ADDENDUM NO. 2

DATE: July 25, 2025

PROJECT: BALL STATE UNIVERSITY AC | MU | TH RENOVATION
BID PACKAGE 4

BALL STATE PROJECT NO: BSU 2023-029.01 AC

FP-200-2

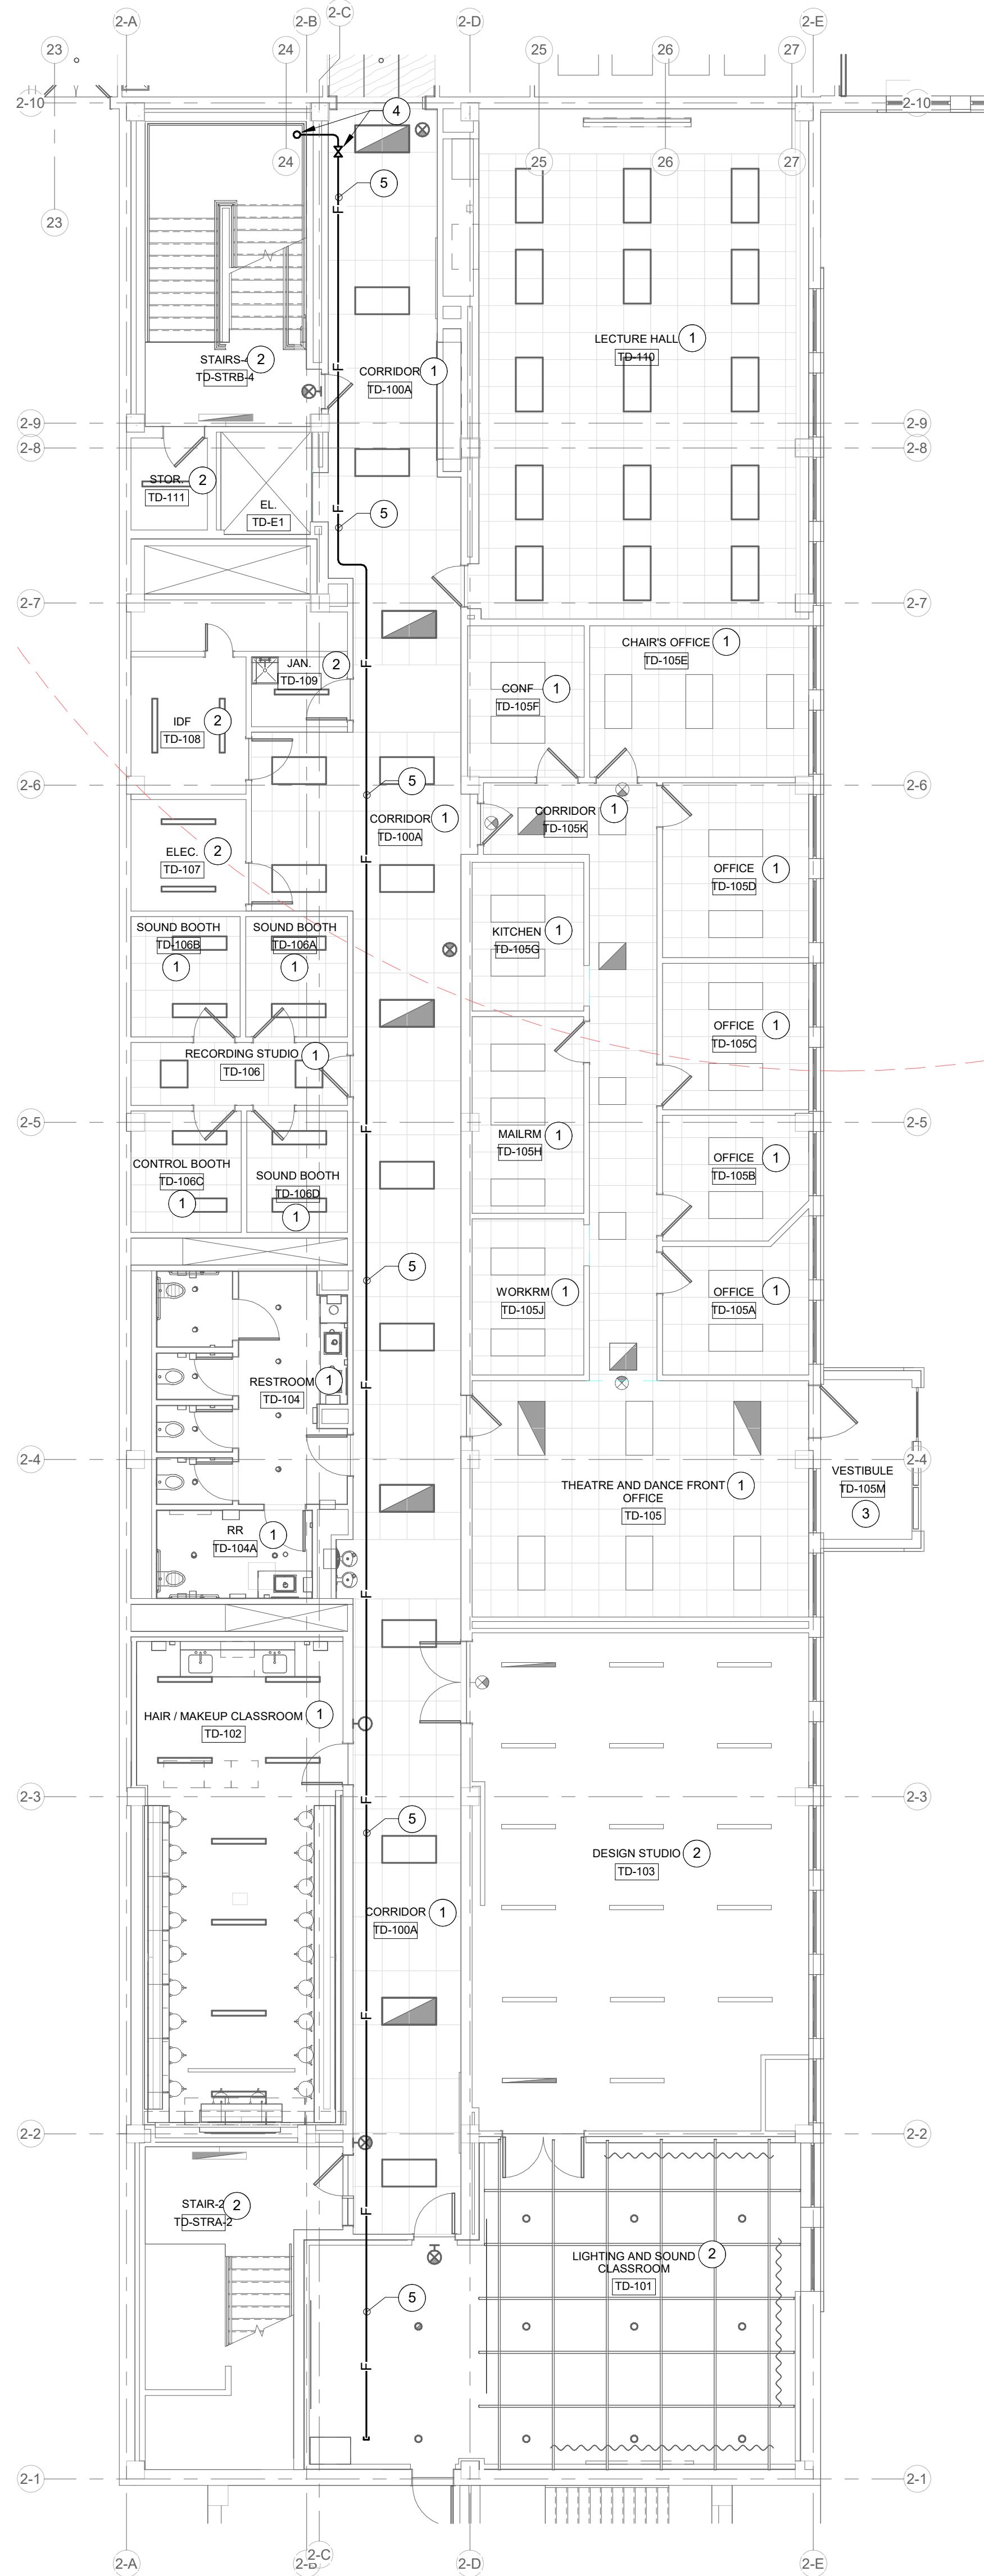
SHEET FP-200-2 – LOWER AND FIRST LEVEL – BLDG. 2 – FIRE PROTECTION

1. Remove installation of sprinkler heads in utility tunnel area.

M-210-2

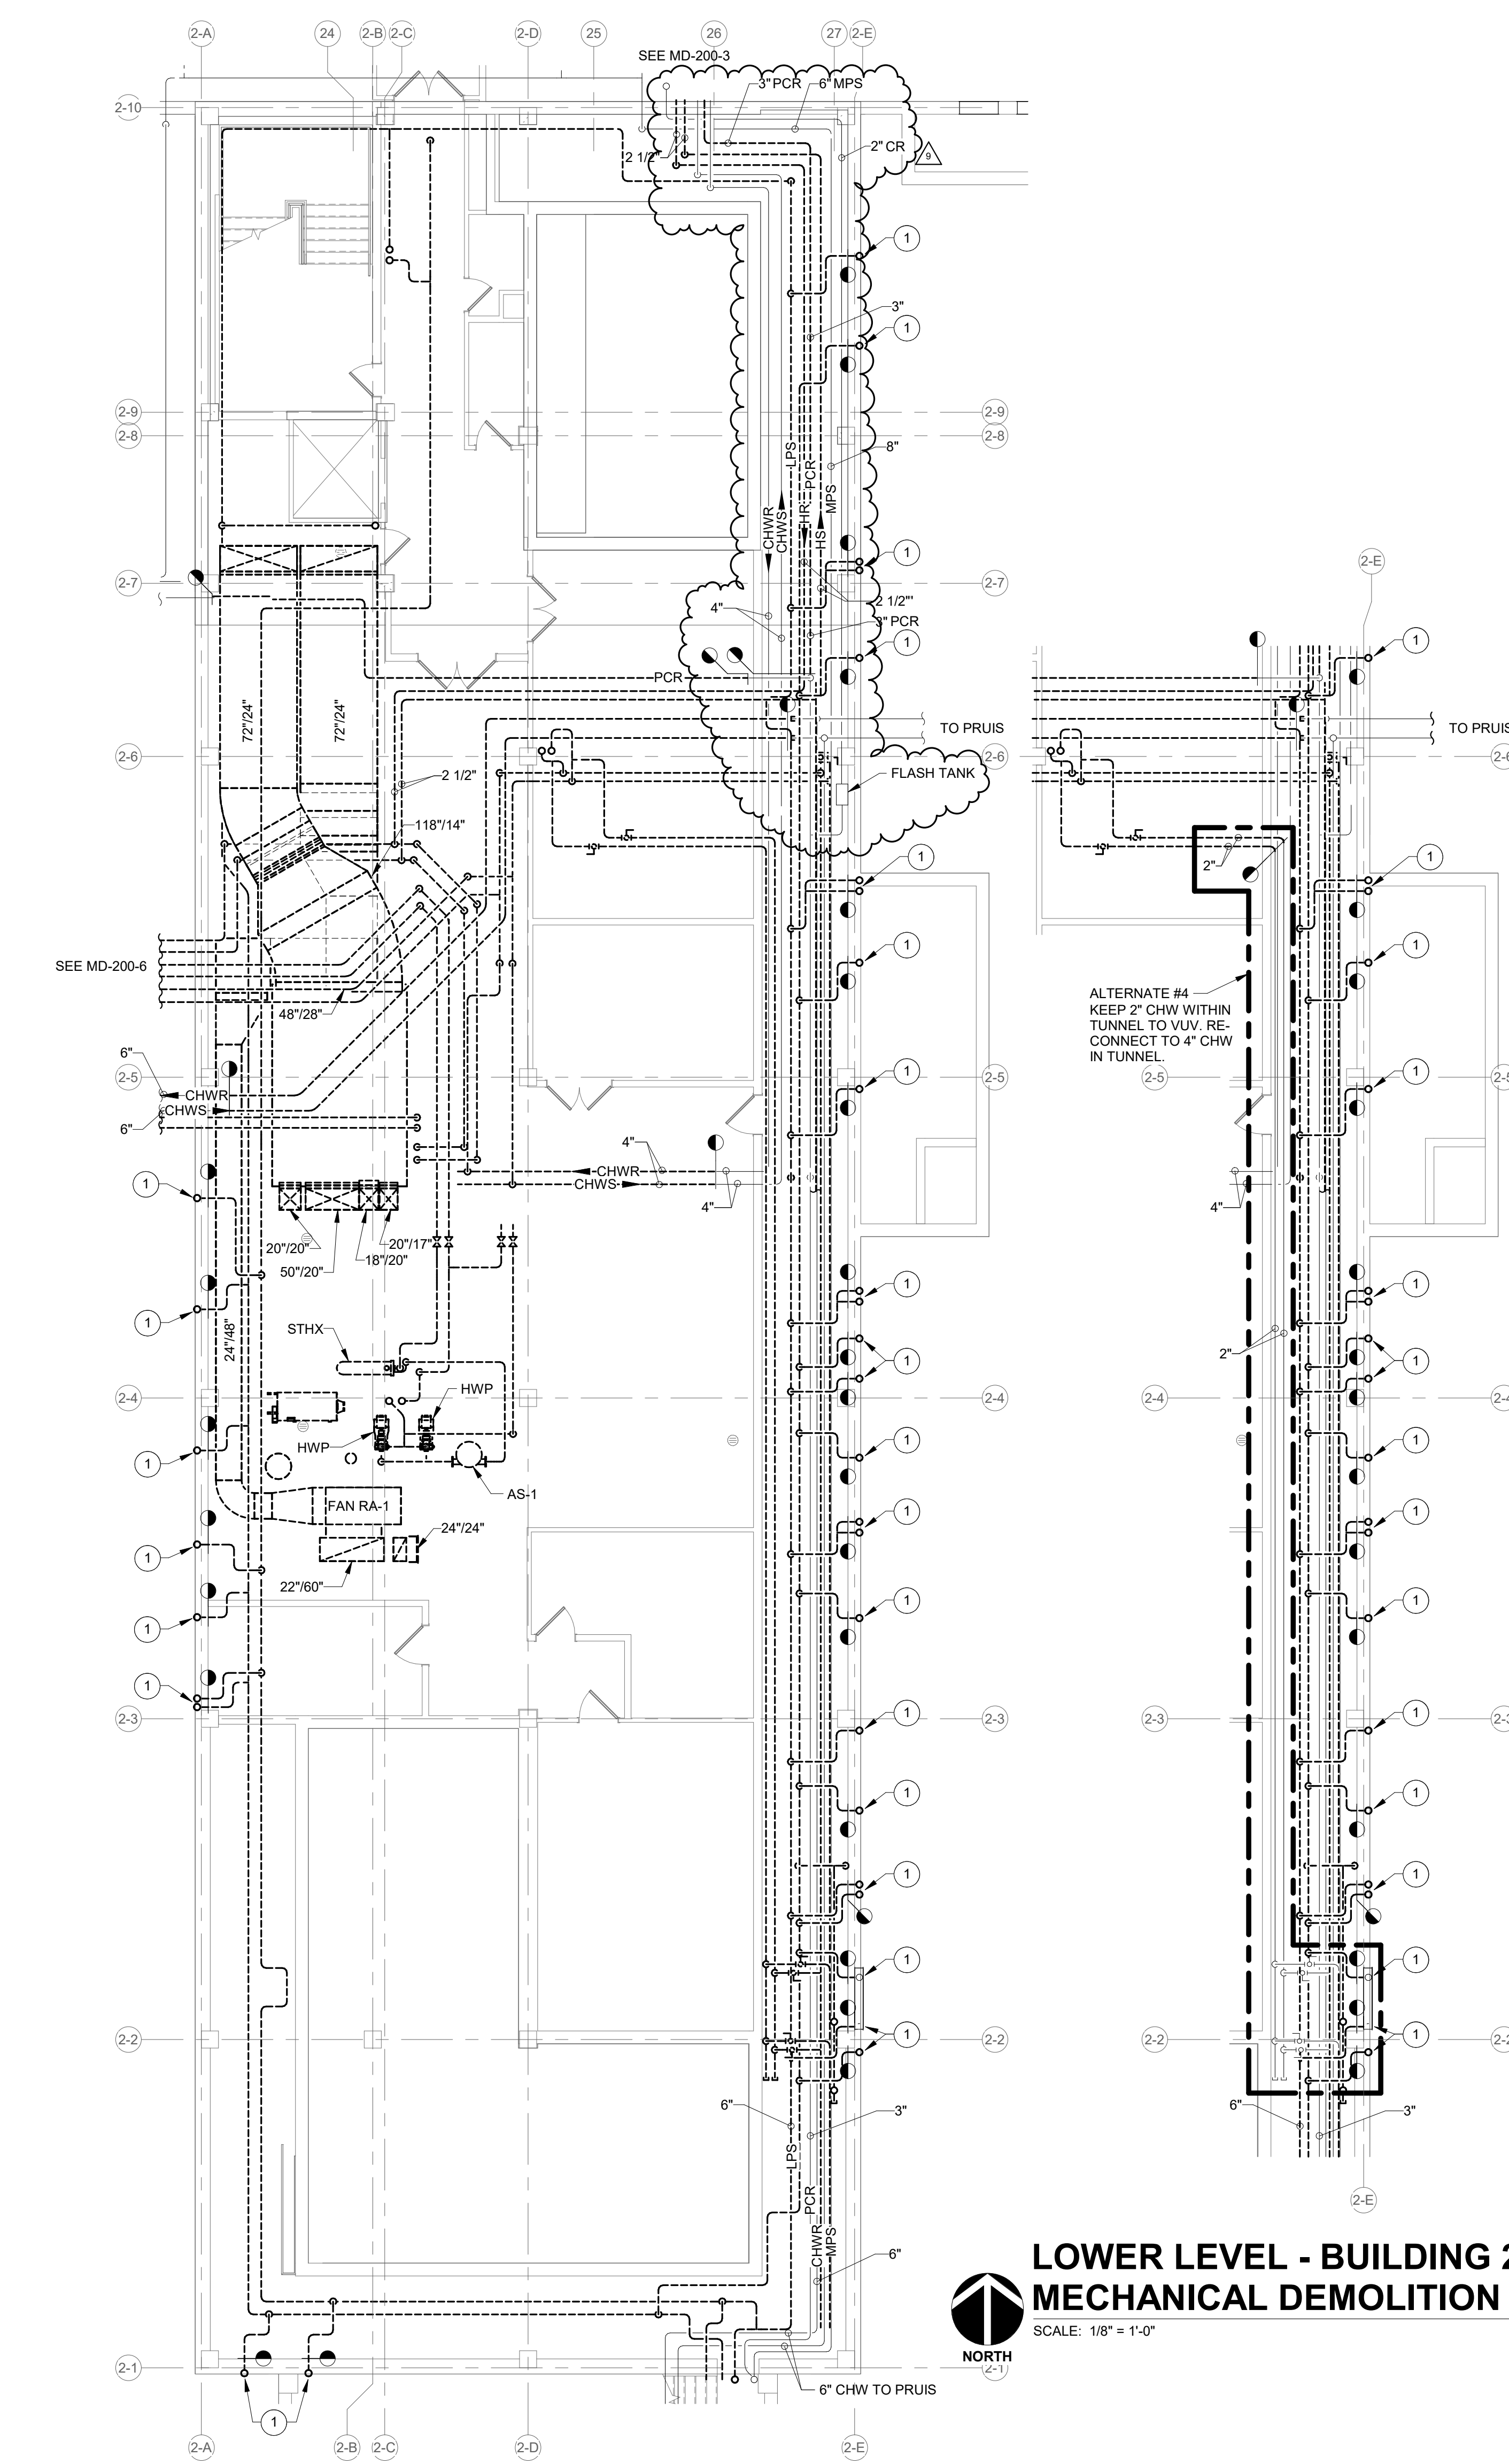
SHEET M-210-2 – LOWER AND FIRST LEVEL – BLDG. 2 - HYDRONICS

1. Revised new and existing Condensate and Pumped condensate lines within tunnel.

SHEET NUMBER
MD-200-2

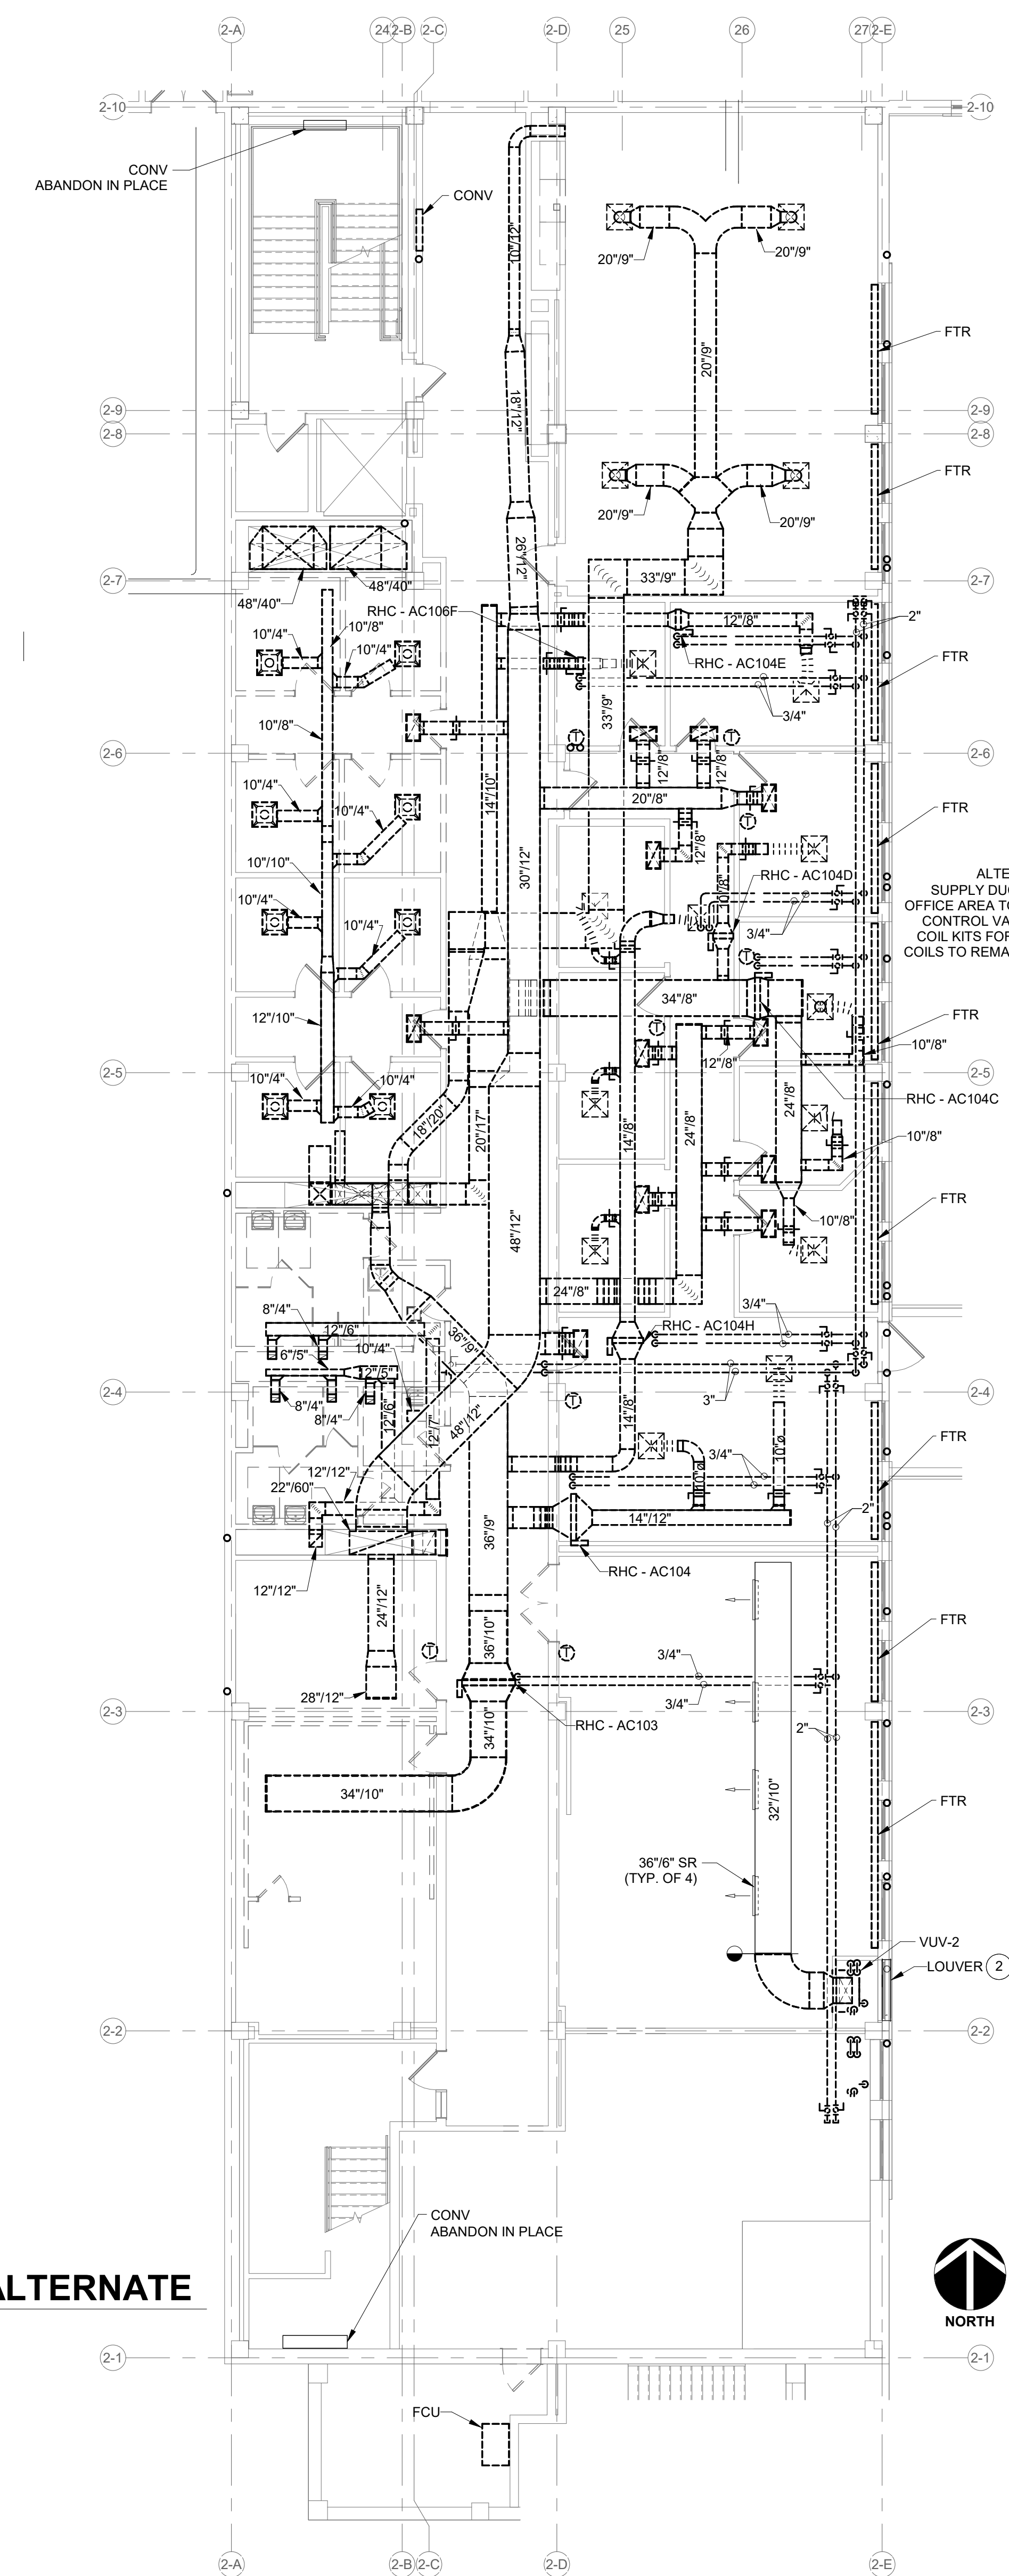
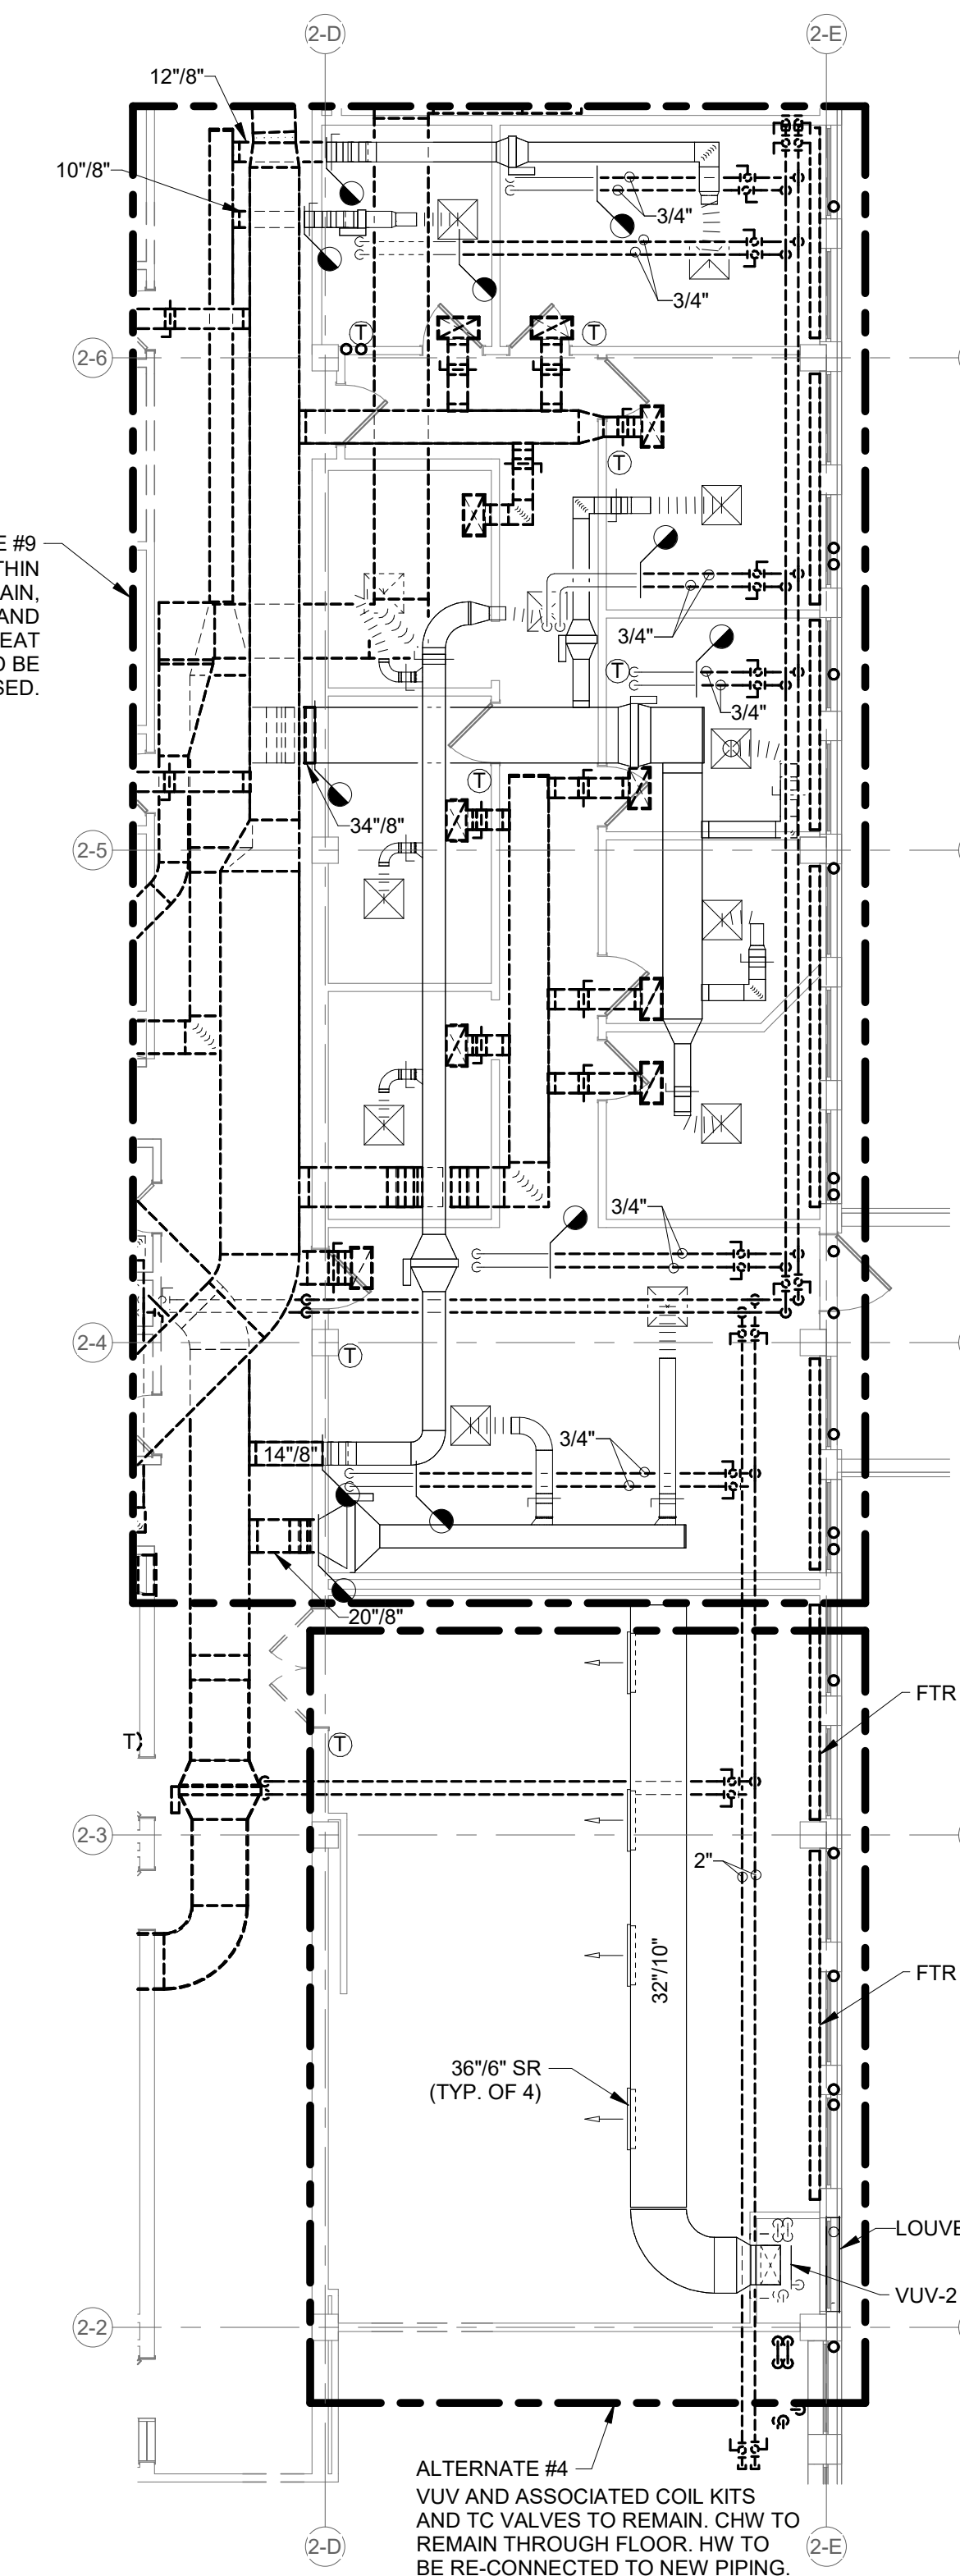
SHEET MD-200-2 – LOWER AND FIRST LEVEL – BLDG. 2 – MECHANICAL DEMOLITION

1. Revised demolition and existing Condensate and Pumped condensate lines within tunnel.
